### Addendum No. 1

### Bear Creek Redwoods Public Access Project

Date: March 27, 2018

#### ADDENDUM NO. 1 – EXHIBIT 2

Sheet Number :	L4.2
Project Number :	16.04
Scale :	1" = 20'-0"
Date :	02/02/18

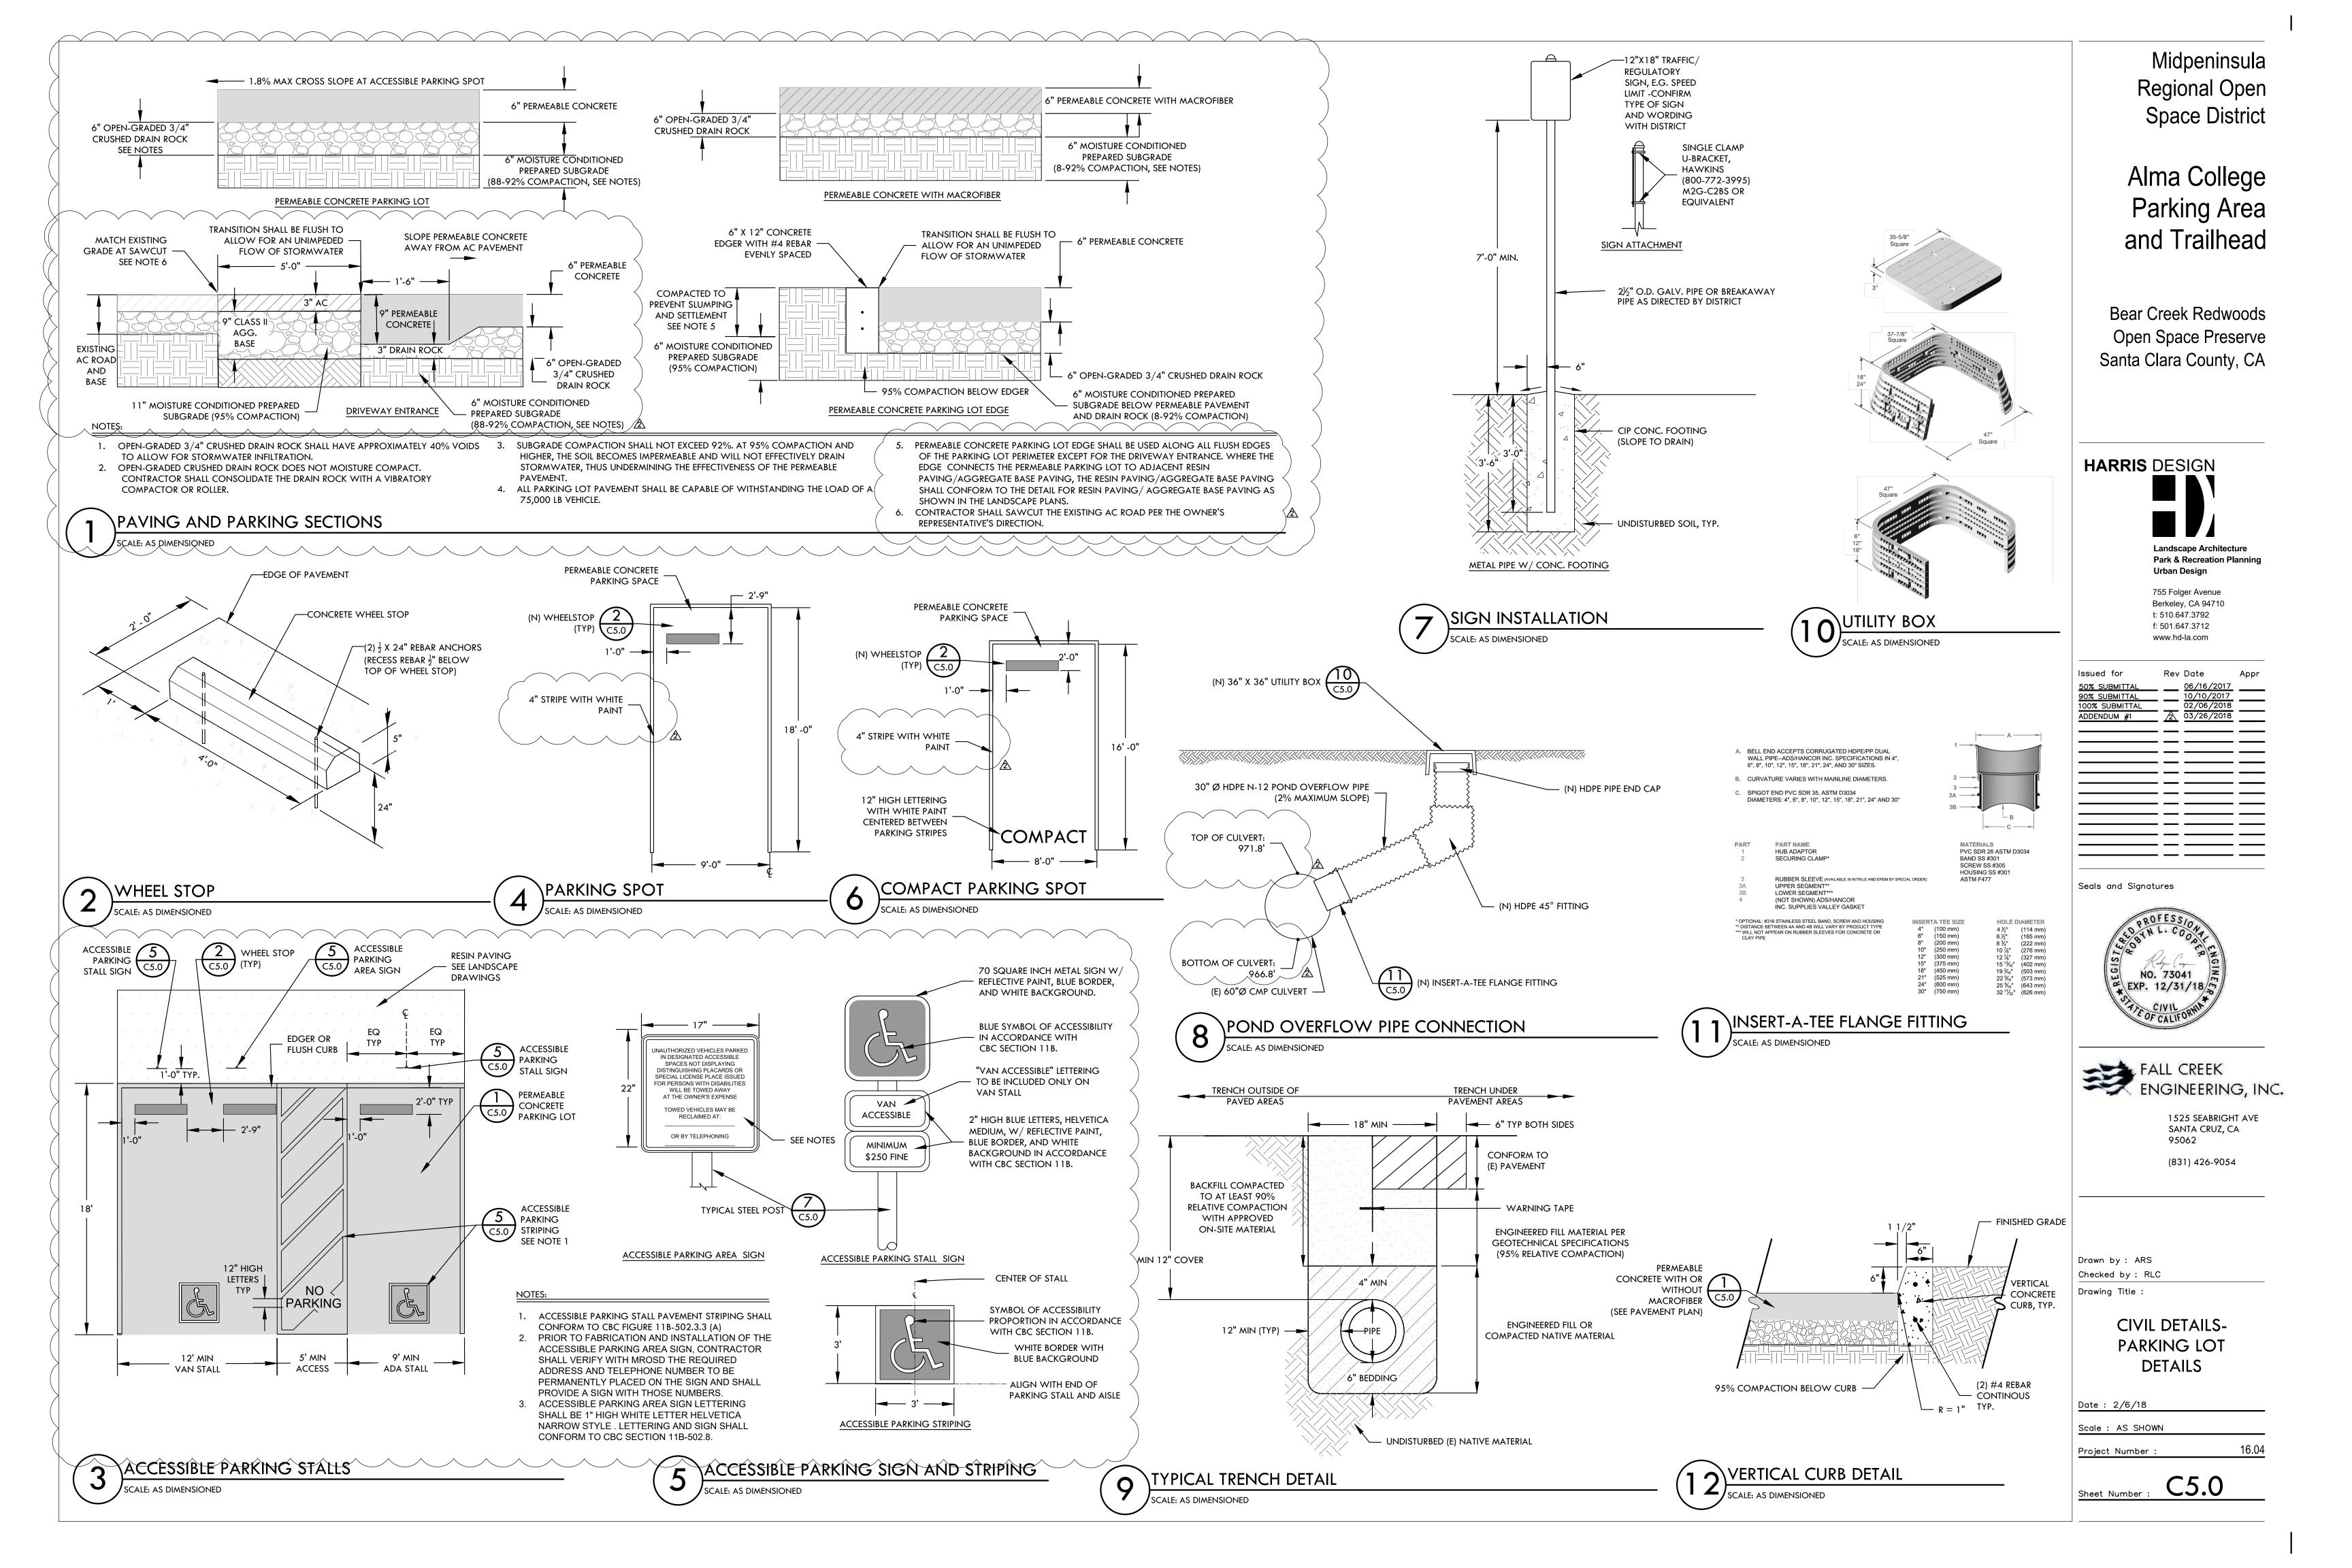
- ii. Sheet L4.2 (Note concerning District Planting)Supplemental Conditions Revised Attachment G CXT Vault Toilet
    - iii. Sheet C5.1
      - a. Border has been updated to include delta 2 submittal and date.

ALL PLANTING AND SEEDING IS NOT IN CONTRACT AND
  WILL BE PROVIDED AND INSTALLED BY THE DISTRICT.
  CONTRACTOR SHALL PROVIDE SOIL PREPARATION
  AND FINE GRADING THROUGHOUT ALL PLANTING AND
  SEEDED AREAS. MULCH WILL BE PROVIDED AND
  INSTALLED BY THE DISTRICT AND IS NOT IN CONTRACT.
